MFN 04-120
November 12, 2004

Subject: Proprietary Content of VY Steam Dryer Audit Report (TAC No. MC0761)

**Technical Audit of Vermont Yankee Steam Dryer Analysis in
Support of Extended Power Uprate Request**

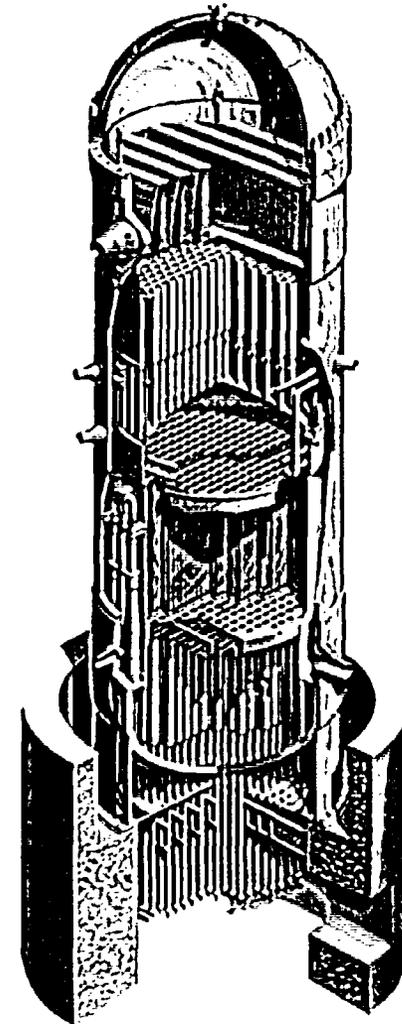
The licensee's use of a scaling factor of 29 at the maximum stress location for the Vermont Yankee steam dryer in its unmodified configuration subject to CLTP conditions might be technically justified based on the absence of high-cycle fatigue cracking at that location. However, the use of the same scaling factor for all other locations on the unmodified and modified Vermont Yankee steam dryer under both CLTP and EPU conditions has not been justified. Scaling factors for locations other than the maximum stress location could be smaller in light of the absence of fatigue cracking at those locations. Therefore, the Dynamic Response Spectrum Methodology used for the fatigue evaluation of the Vermont Yankee steam dryer might not be conservative.

The stress results for the modified dryer subject to CLTP conditions indicate that the oscillating stress at the outer hood cover plate location (maximum stress location in the unmodified dryer) has decreased because the thickness of the cover plate was increased from 0.25 inches to 0.625 inches. However, the oscillating stresses have increased at some other locations in the modified dryer where the original plate thickness was not changed. In the modified dryer, the
